ATLASSIAN CENTRAL DEVELOPMENT

SSD-10405 RESPONSE TO SUBMISSIONS & SUPPLEMENTARY DESIGN REPORT

30/06/21

FIGURE 1 - INDICATIVE TECHNICAL SECTION - LEVEL 27

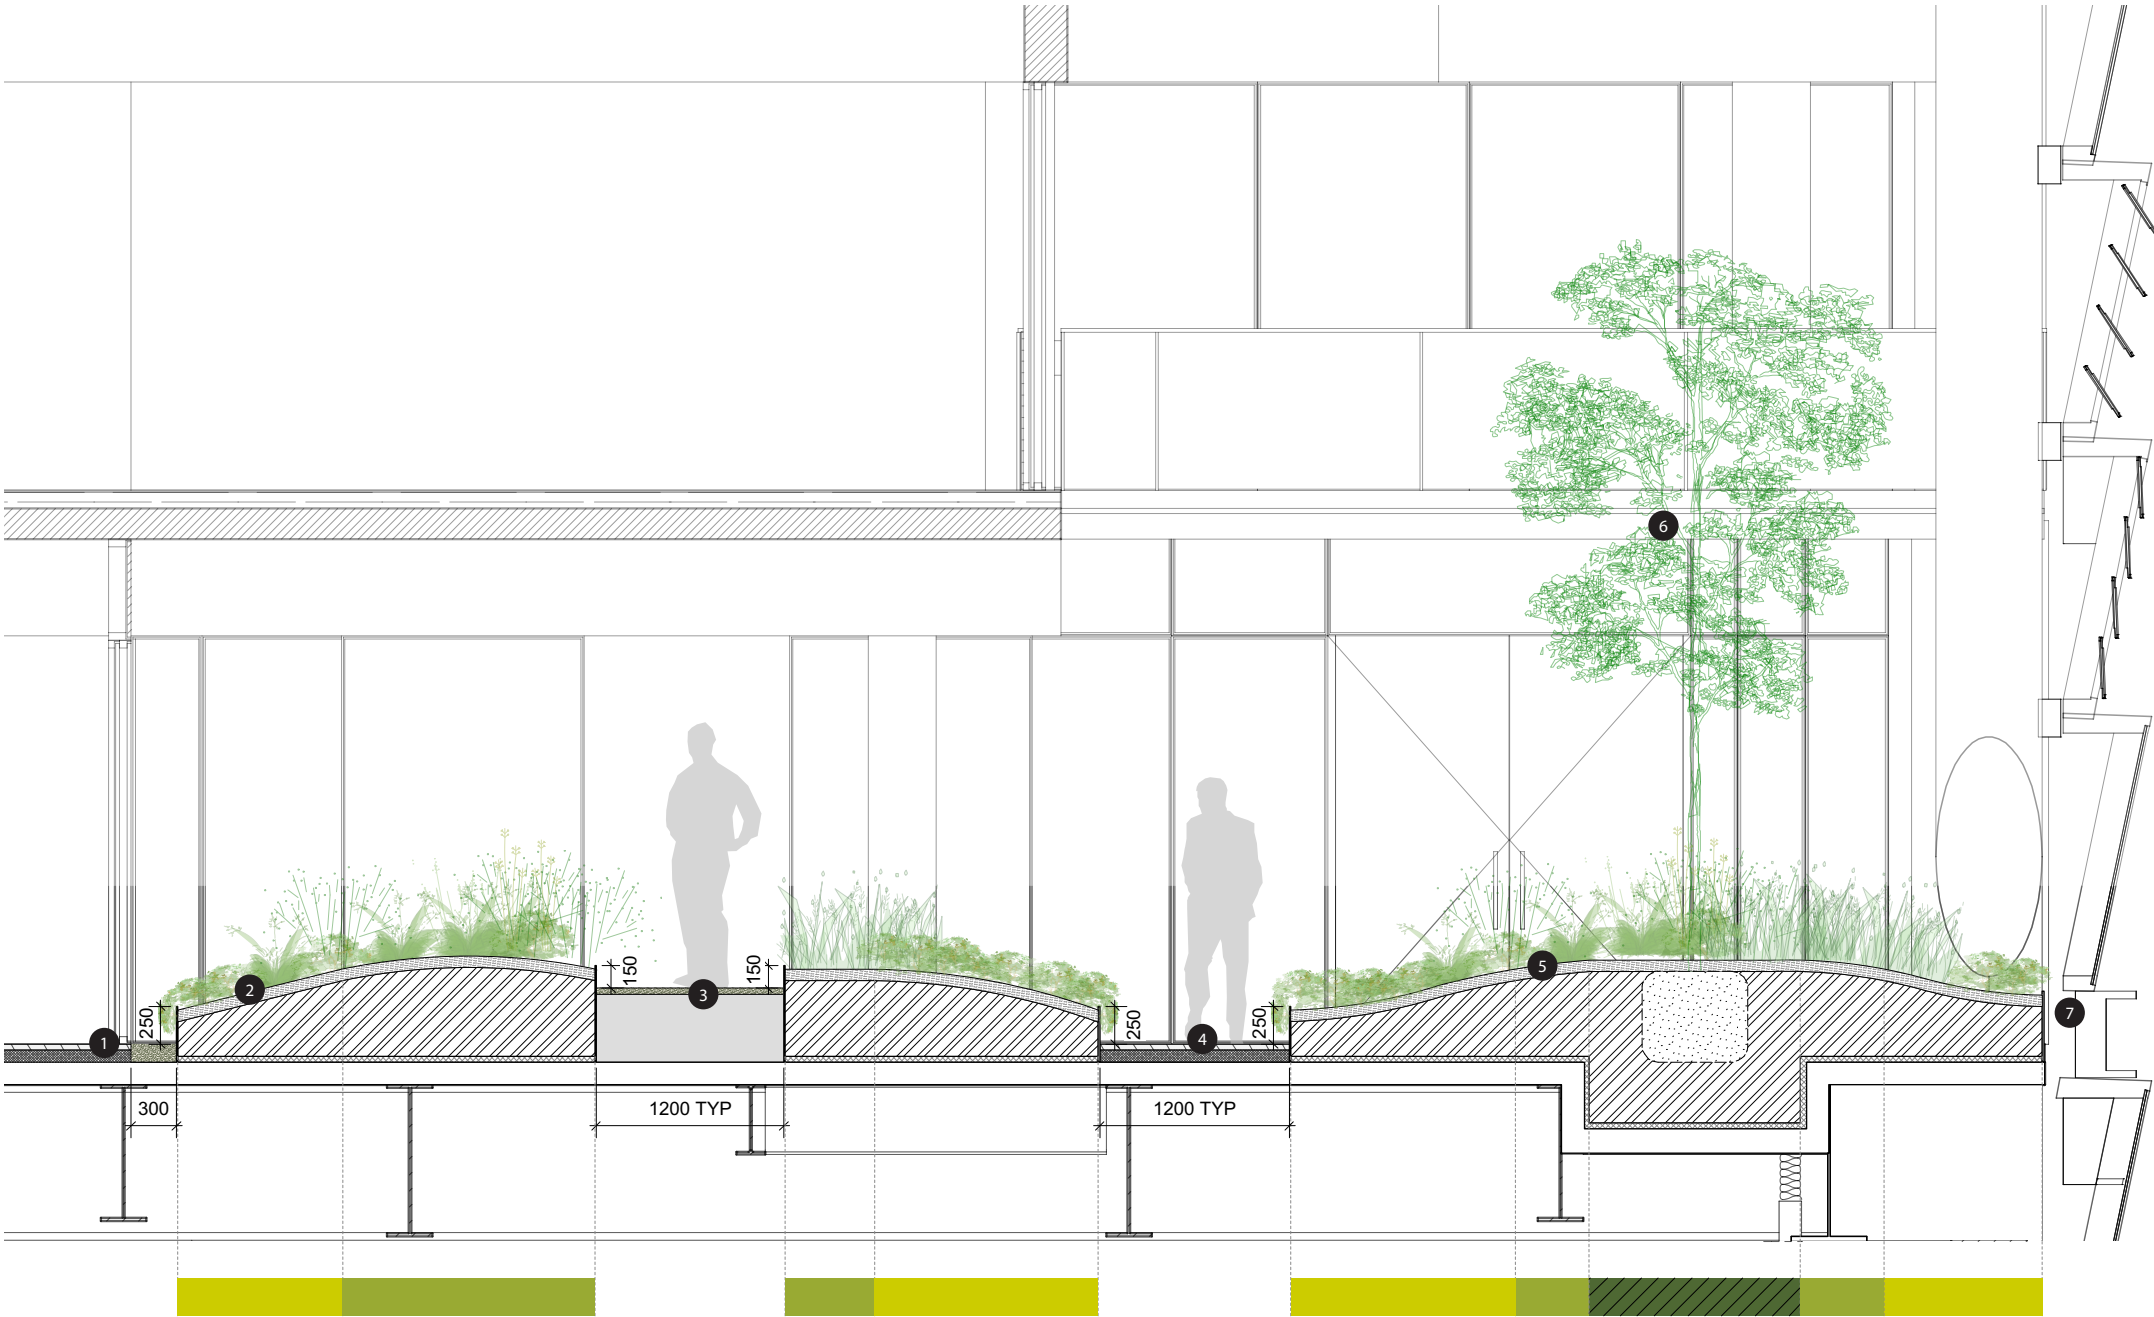
1.1.24 COS COMMENT: CROWN LANDSCAPE

- SOIL DEPTH 300-500MM
- SOIL DEPTH 500-600MM
- SOIL DEPTH 600-800MM (WITHIN STRENGTHENED ZONE OF FLOORPLATE)

FIGURE 1 - HERITAGE FABRIC RETENTION STRATEGY

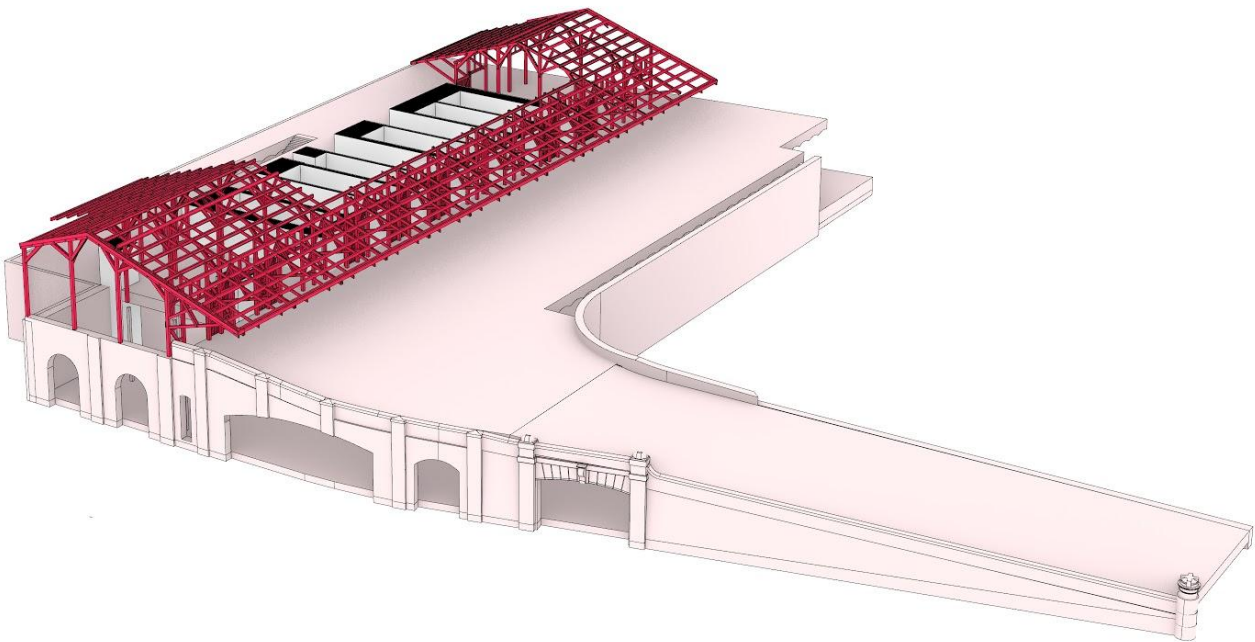
We note that further detail design development will be undertaken on the building and that as much original timber framing as possible will be reused in the building’s adaptation. However, it is still unclear how other distinctive elements of the building, including the existing masonry base and chimneys, and sandstone plinths of the building will be meaningfully used as part of the adaptation and interpretation of the building. Further detail is required as per Heritage Council letter to the applicant, 16 October 2020.	Refer to 1.2.1 Heritage NSW Comment
In addition, the document notes removed significant fabric will be reused where possible. Further detail is required to understand what elements will be reused and in what application, including interpretive measures.	Refer to 1.2.2 Heritage NSW Comment

See Figures 1 and 2.

FIGURE 3 - SECTION DETAIL THROUGH FIRE BOOSTER CUPBOARD

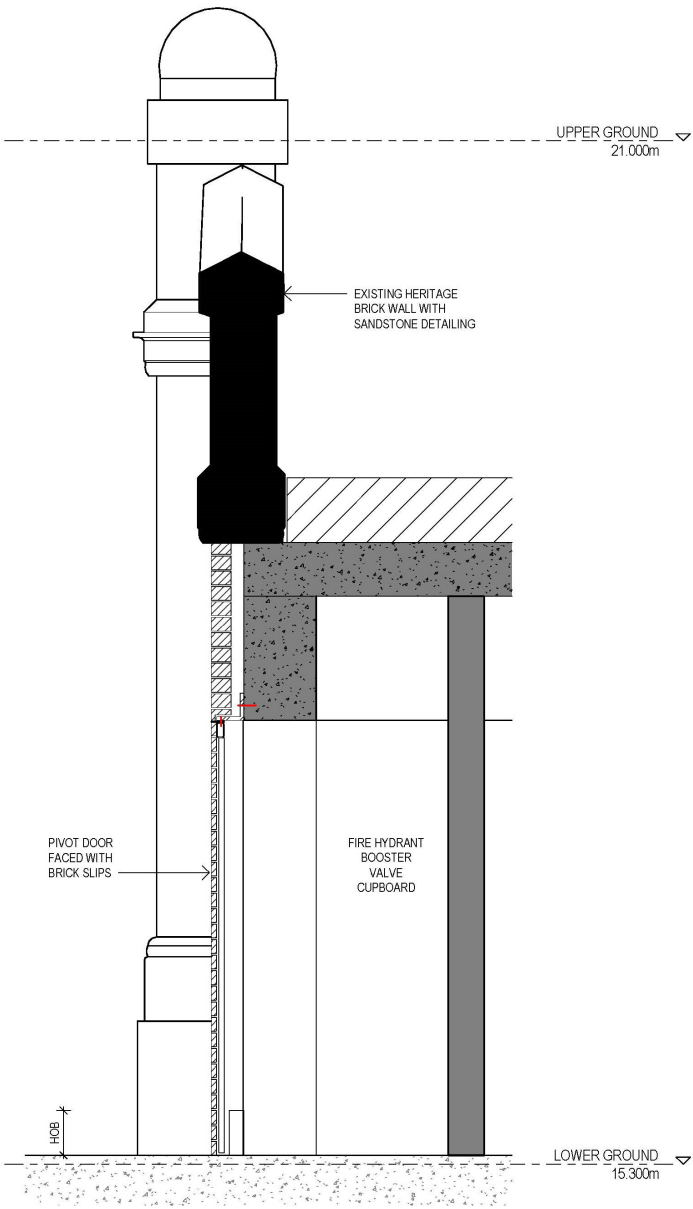
Heritage NSW Comments	Response
Modification to surface levels to the west of the former Inward’s Parcel Shed and along Upper Carriage Way are proposed to occur. It is unclear what impact the change in surface level will have on the adjacent significant retaining walls and the former Parcel Post Office building as well as the sandstone post on Upper Carriage Lane. We suggest additional details be developed to ensure impacts are minimised, including how the use of the former Inwards Parcels Shed including its loading dock function will be interpreted as part of the works.	Refer to 1.2.3 Heritage NSW Comment
Further details of the fire booster proposed to be installed within the heritage retaining wall (Lower Carriage Lane) should be provided to ensure the treatment does not adversely impact on the character of the wall.	Refer 1.2.4 Heritage NSW Comment

Pivot doors faced with brick slips to match the existing brickwork will be selected in order for the booster cupboard to be integrated with the heritage wall. See figure 3.

FIGURE 1 - SHADOW DIAGRAMS FOR 38 CHALMERS STREET AND SURROUNDING RESIDENTIAL AREAS

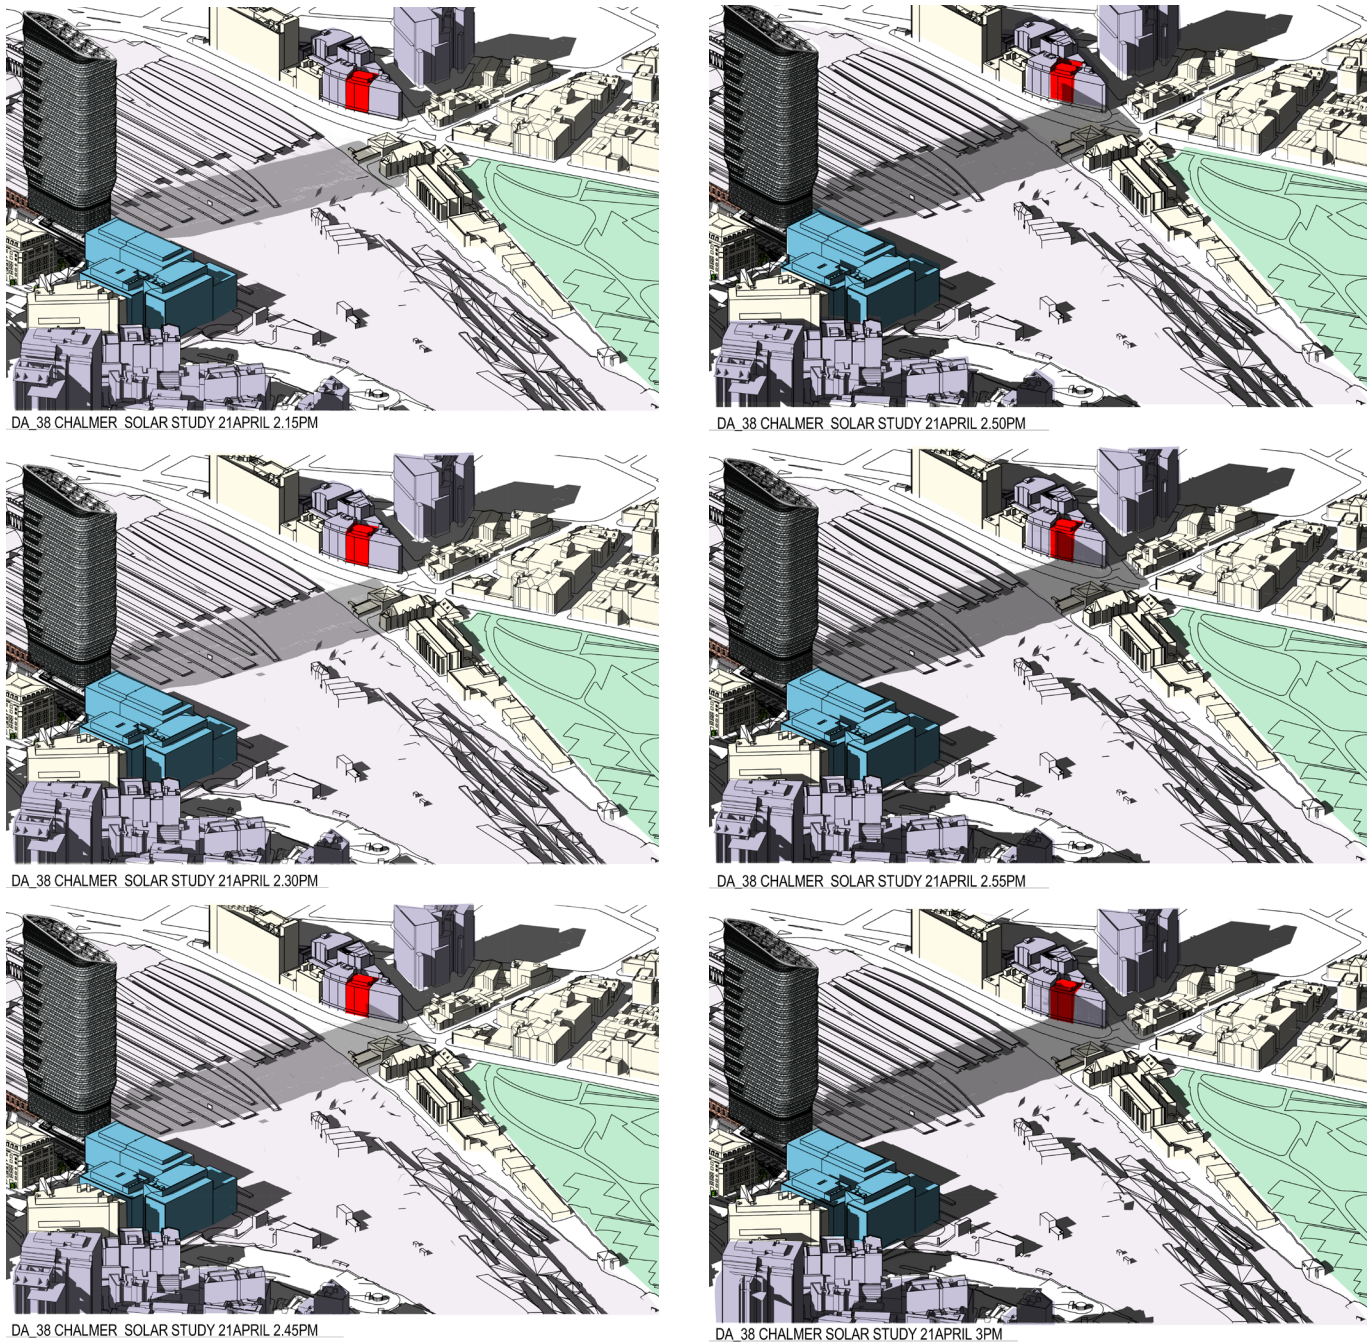
Public Submissions	Response
Objections	
"I am the owner of an investment property at 38 Chalmers St Surry Hills. As such I am concerned that no visual or solar impact assessment has been made for our buildings (34 and38 Chalmers st are residential buildings). We stand right across the railway from the proposed 40 storey towers the height and bulk of which, will no doubt impact our enjoyment of the afternoon sun (the only time we get sunlight) and be visually obtrusive. While the Atlassian tower on its own, might not create too much of an issue, the assessments shouldshould be made for the impact from the entire project. As the projected view from Prince Alfred Park shows, we will be looking at a massive wall of 3 towers with minimal space between them when the Fraser Dexux buildings are added to the picture. That is of course less than an idyllic view from all directions. Moreover, I really believe that the area could have been redeveloped with much more regard for the heritage buildings around and more imagination. Of course it's just about money so skyscrapers are all the go whether suitable or not. They will ruin an area that could have retained so much character with wholistic planning rather than ad hoc unsolicited development proposals.. There is no planning here... Now that there is a 4th tower in the works (Toga above the Adina Hotel) , the impact on the lovely heritage buildings will be worse than one can picture. The white shadows on the assessment photos hardly show the reality I also do not see such a great need for more office space, hotel rooms and or retail space in the area in a city already full of those with many vacant and for lease. A missed opportunity by Planning NSW and City Council alike to make the Southern end of the CBD amore open, light filled, pedestrian friendly, character full area working to enhance what is already there rather than dwarf and disrespect it."	Refer 1.3.1 Public Submission Comment

1.3.1 PUBLIC SUBMISSION COMMENT: SHADOWS TO 38 CHALMERS ST

FIGURE 1 - SECTION THROUGH EASTERN BOUNDARY WITH CENTRAL STATION

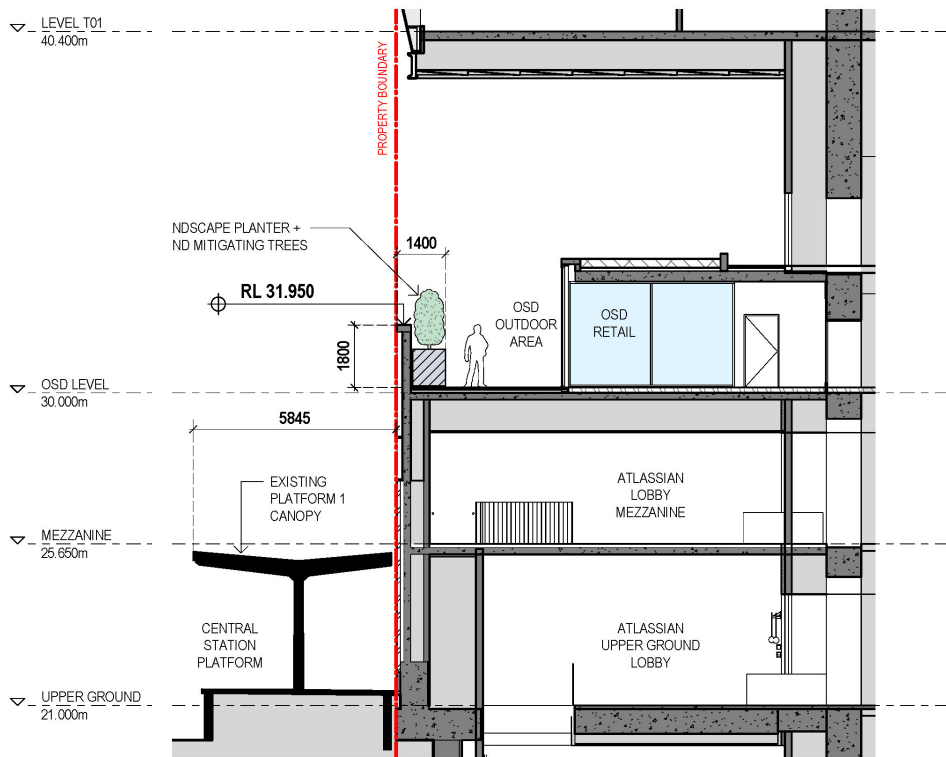
TFNSW Comments	Response
Protection of Sydney Trains / NSW Trains Assets and Operation	
Central Station is located in close proximity to the proposed development. It is noted that: • It appears that lower part of roof top outdoor terrace facing rail corridor does not include any measures to prevent throwing/falling of objects or opportunity for self-harm; and • The development application identifies groundwater drawdown as an issue. It is advised that: • Possession works be managed by Sydney Trains (not TfNSW as mentioned in Appendix Z); • Section 2.5 of Appendix Z needs to include TAHE as one of the authorities which need to be liaised with; and • Section 2.6 of Appendix Z needs to include Sydney Trains as one of the stakeholders for the preparation of Stakeholder Management Plan. Recommendation It is requested that the applicant provides the following as part of the applicant’s Response to Submissions: • Details of outdoor terrace area, balconies and external windows facing rail corridor and confirmation that the development has measures installed (e.g. awning windows, louvres, enclosed balconies, window restrictors etc.) which prevent the throwing of objects onto the rail corridor in accordance with the Department of Planning’s Guidelines - Development near Rail Corridors and Busy Roads; • Impact of groundwater drawdown on rail corridor needs to be assessed in detail and confirm this is acceptable; and • Whether the applicant will be seeking staged Construction Certificate as TfNSW would be able to recommend any relevant conditions that apply for each specific stage.	Refer 1.5.1 TfNSW Comment

The eastern property boundary adjoins Platform 1 of Central Station. At OSD level on the eastern boundary it is proposed to have a 1.8 metre high solid metal plate screen with a landscape zone 1.4 metres wide, with plants and trees higher than 1.4 metres separating people from the accessible terrace. (See Figure 1) Below the eastern wall and screen is the roof canopy over platform 1 which will also provide protection to pedestrians and the track below. Further protective measures maybe required and the detail will be worked through with TfNSW to achieve a suitable solution.

The Crown outdoor terraces are separated from the eastern boundary with Central Station with a planting zone and 2 metre balustrade which varies in width between 1 to 3 metres. (See Figure 4) The 2 metre high screen is required to provide seated wind comfort for occupants on the terrace from southern winds.
